Item Name: Crosstube Turning Detail

DART AEROSPACE LTD	Work Order: 74938
Description: Crosstube Assembly	Part Number: D407-667-145
Inspection Dwg: D407-667-145 Rev: C	Page 1 of 1

DRAWING NO. D407-667-145	TITLE CROSSTUBE ASS'Y (407 HIGH FWD)	REV. C	DART AEROSPACE LTD ENGINEERING ORDER		D.E.O. NO. D407-667-145-C-1	SHEET NO. SHEET 1 OF 1	SCALE NTS
DRAWN 97	CHECKED ASS	MFG. APPR. 123	APPROVED WD	DE APPR. H			
DATE 11.07.15	DATE 11.07.22	DATE 11.07.22	DATE 11/07/22	DATE 11.07.21

PURPOSE:
REPLACE MAGNOBOND WITH PROSEAL.

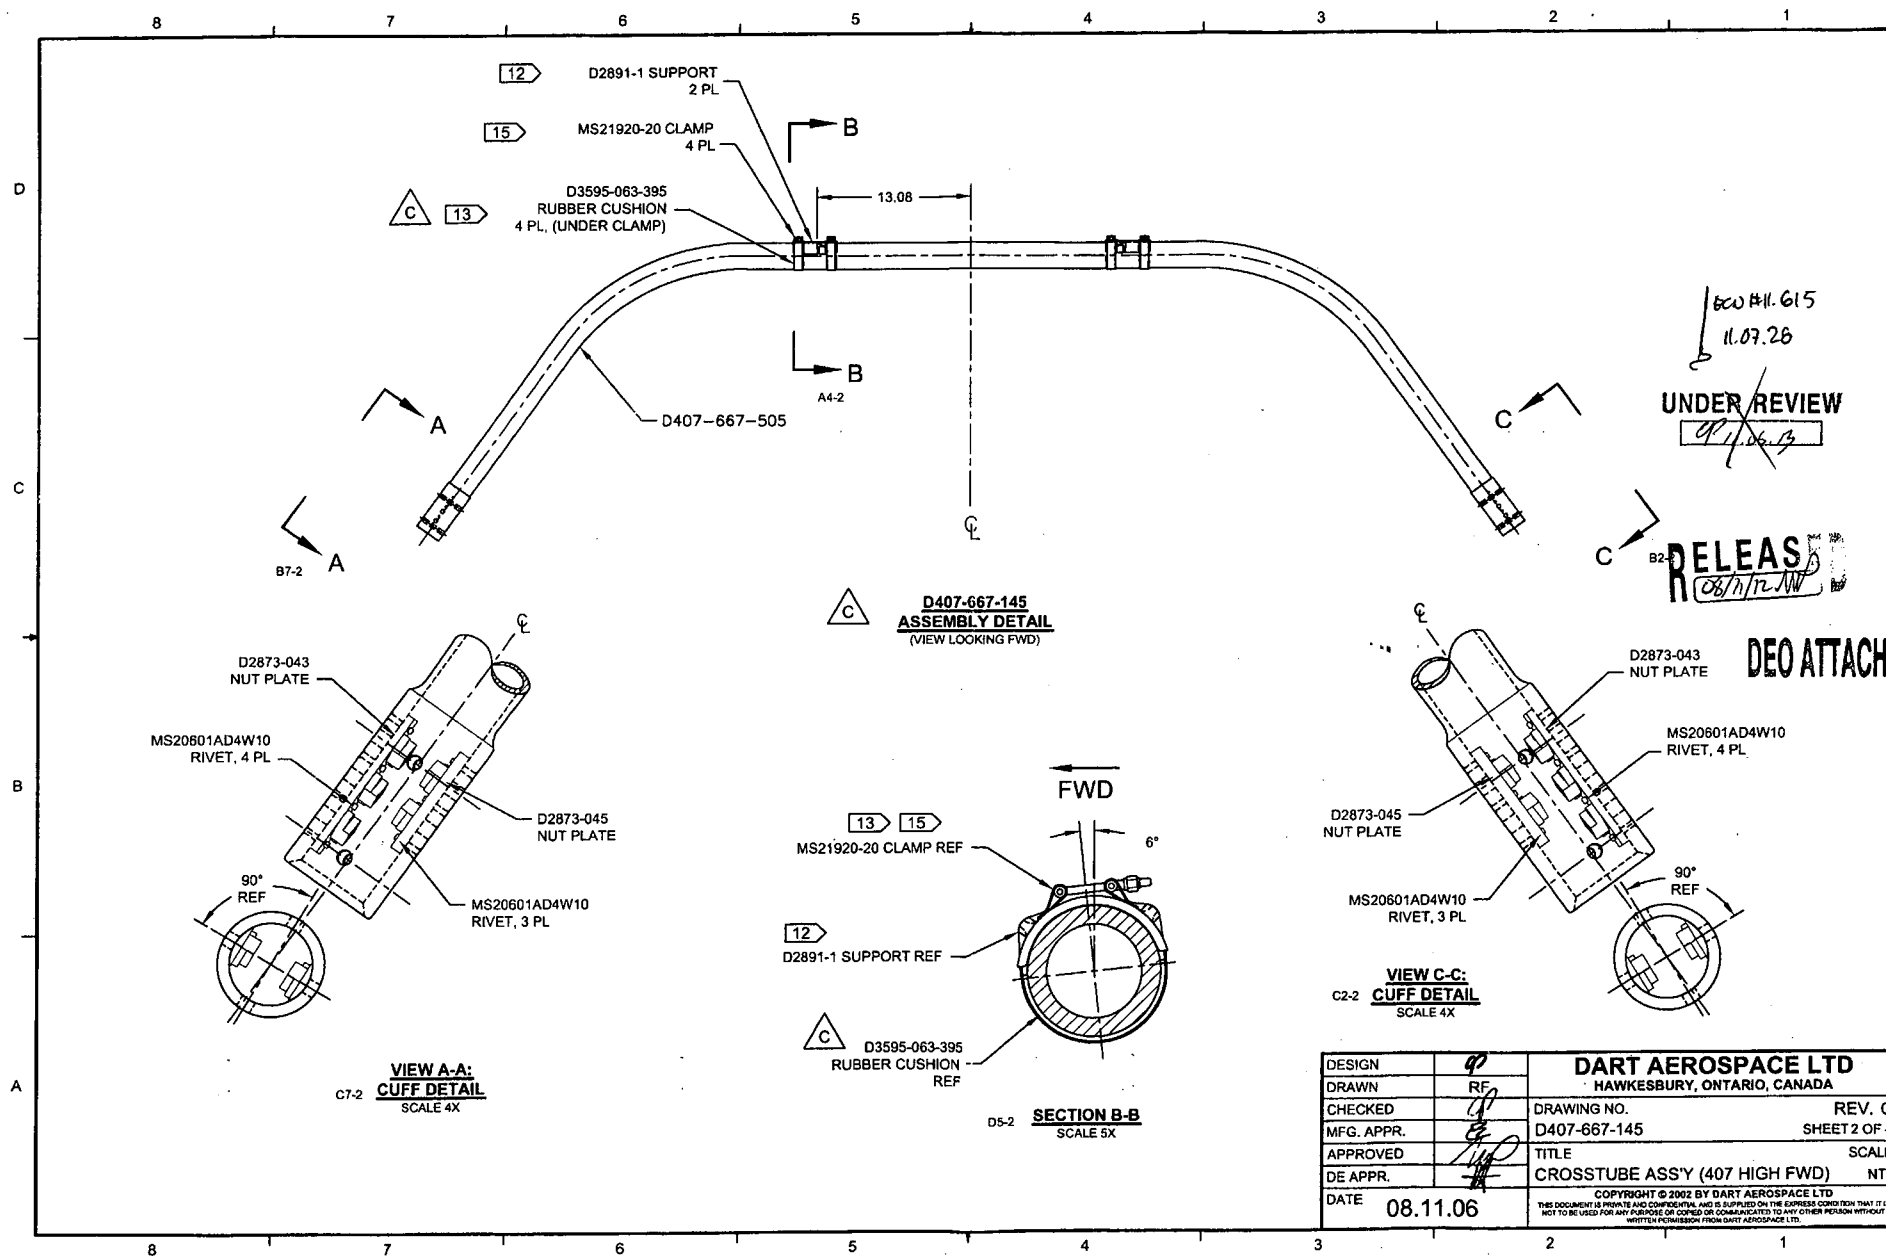
NOTE 12 & 15, SHEET 1 IS AMENDED AS FOLLOWS:

- 12) TO INSTALL D2891-1 SUPPORT: ABRABE MATING SURFACE OF SUPPORT AND CROSSTUBE WITH 180-GRIT SANDPAPER AND REMOVE RESIDUE WITH MEK (OR EQUIVALENT). APPLY A 0.04" TO 0.07" THICK LAYER OF PROSEAL 890 CLASS B-2 (OR AMS-S-8802 CLASS B-2) SEALANT TO MATING SURFACE OF SUPPORT.
- 15) TORQUE CLAMPS 80 TO 100 IN-LB. ENSURE AT LEAST 1.5 THREADS SHOWING IN SAFETY AND THAT NUT HAS NOT BOTTOMED-OUT AFTER TORQUING. **PRIOR TO PACKAGING, RE-CHECK TORQUE ON CLAMPS AFTER PROSEAL 890 SEALANT HAS CURED FOR 72 HOURS.**
